Marine Mammal Mitigation Protocol

Appendix: Marine Mammal Mitigation Protocol

Document no.	
Project/s	North Irish Sea Array (NISA) Offshore Wind Farm
Originator Company	North Irish Sea Array (NISA) Windfarm Limited
Document Type	PN- Plan, Management Plan
Package	ENV - Environmental
Revision	Addendum
Classification	N/A
Date	6/9/2026
Author	APEM Ltd/ GoBe/SMRUC

Appendix A: Pile driving mitigation procedure summary

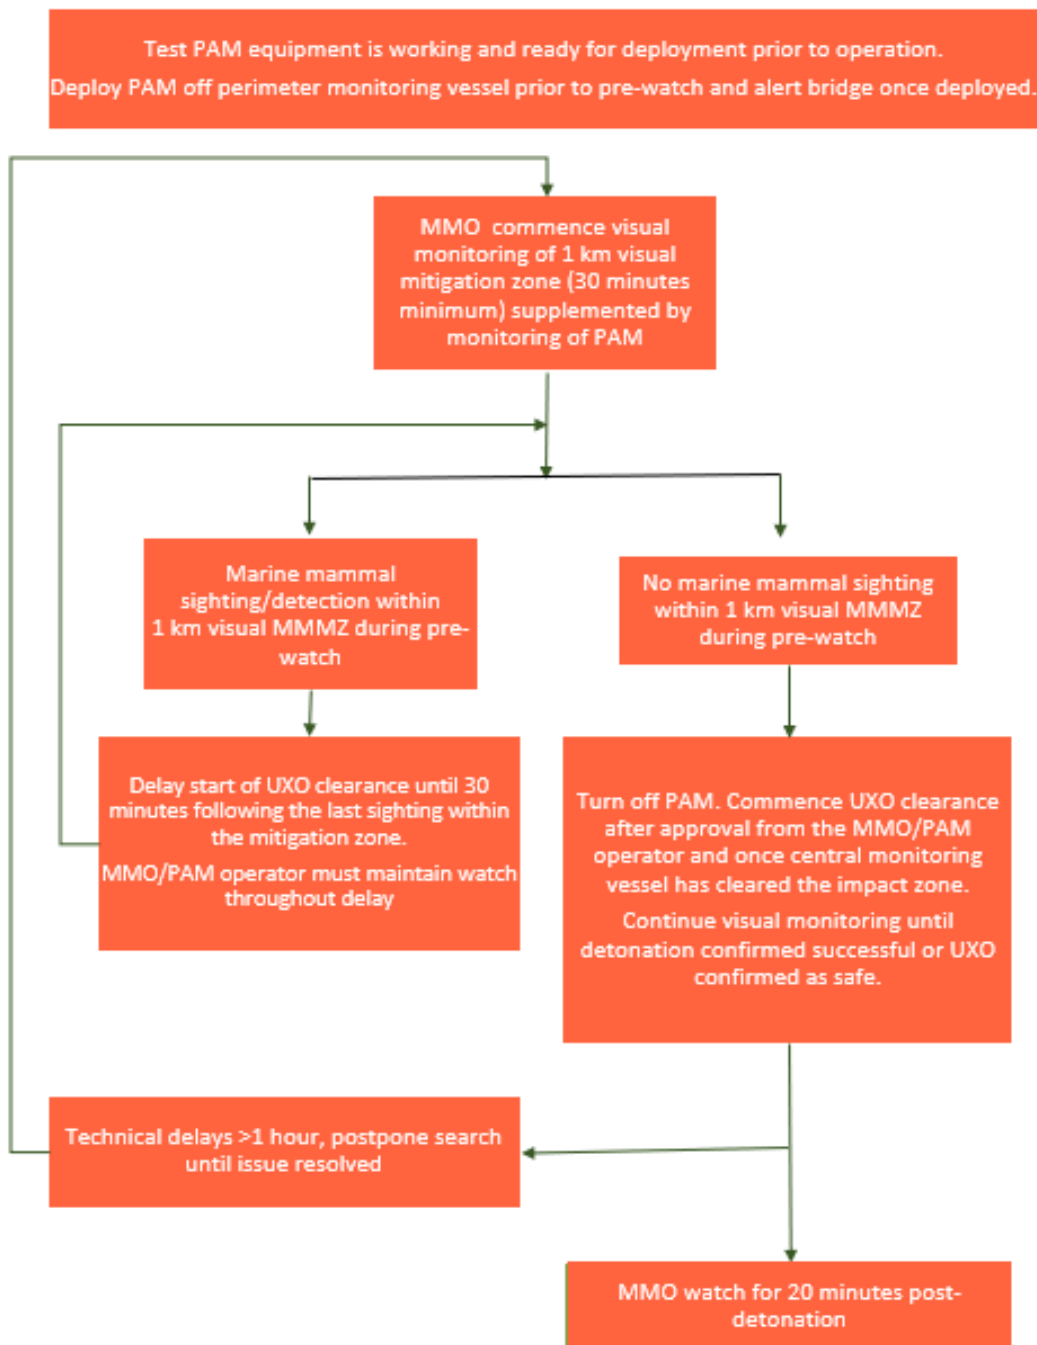
The change required in this section is in response to the refinement of the foundation installation types for Project Option 1 and Project Option 2 (refer to Appendix A5.1) with WTG jacket foundations being installed with suction buckets and OSP jacket foundations being installed with either drilled pin piles or suction buckets. Therefore, pile driving has been removed from the 2024 MMMP and Appendix A of the 2024 MMMP can be disregarded.

Appendix D: High-Order UXO mitigation procedure summary (replaces Appendix C in the 2024 MMMP). This procedure summary assumes the NAS is a bubble curtain (as an example). This will need to be modified for any other at-source noise reduction methods.

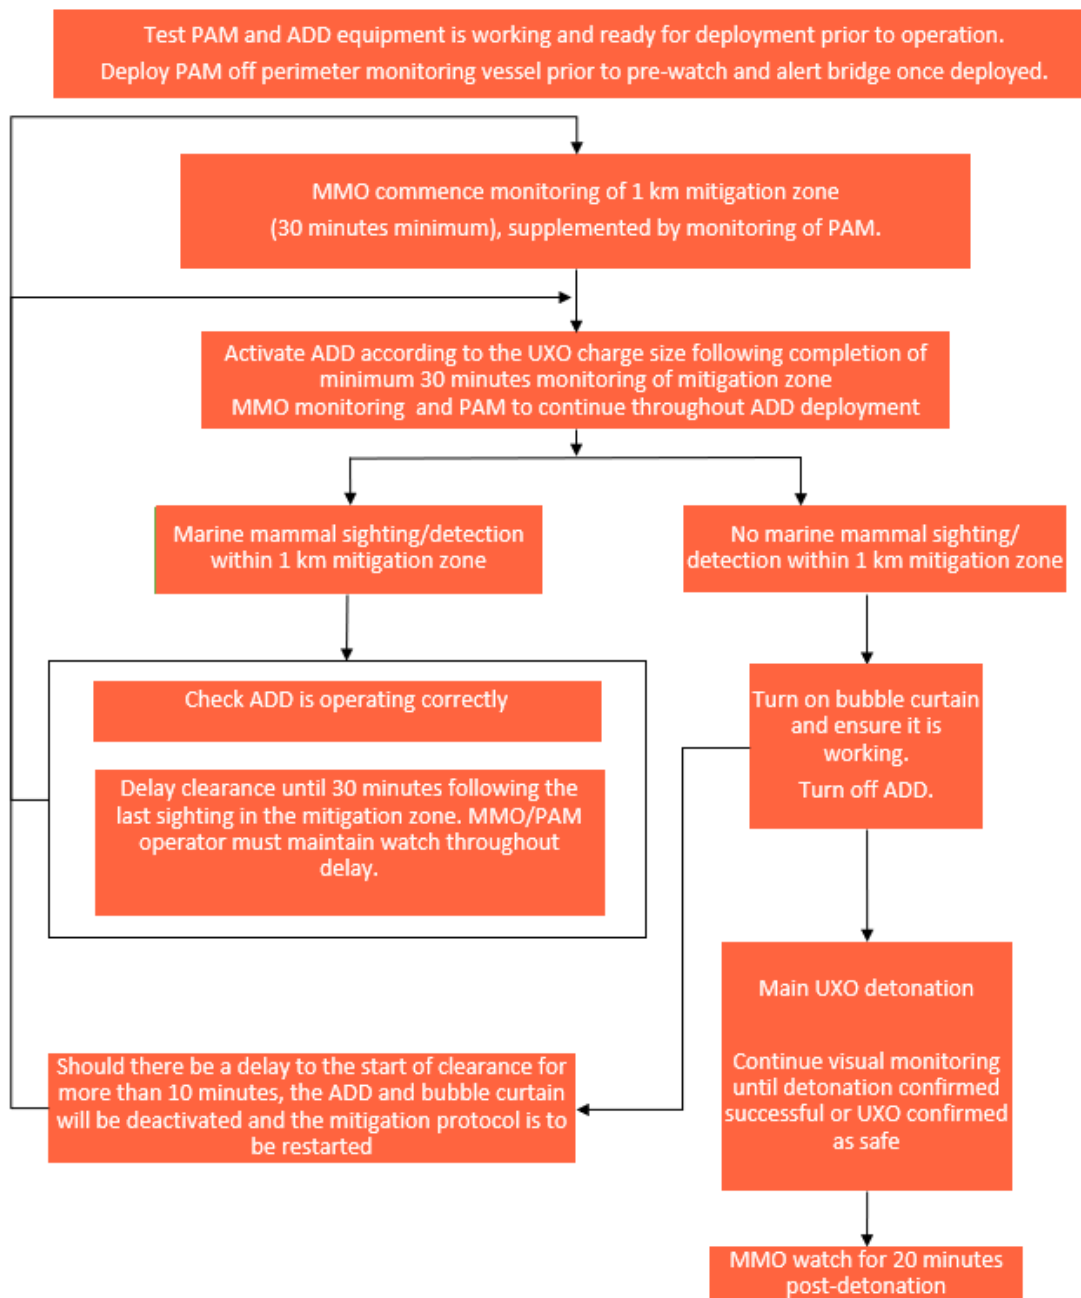
In response to RFI Section 10 (c), the key change for this section is the commitment from the Developer to use a NAS (e.g., bubble curtain) for any high-order clearance. Therefore, Appendix C of the 2024 MMMP shall be deleted and replaced with Appendix D.
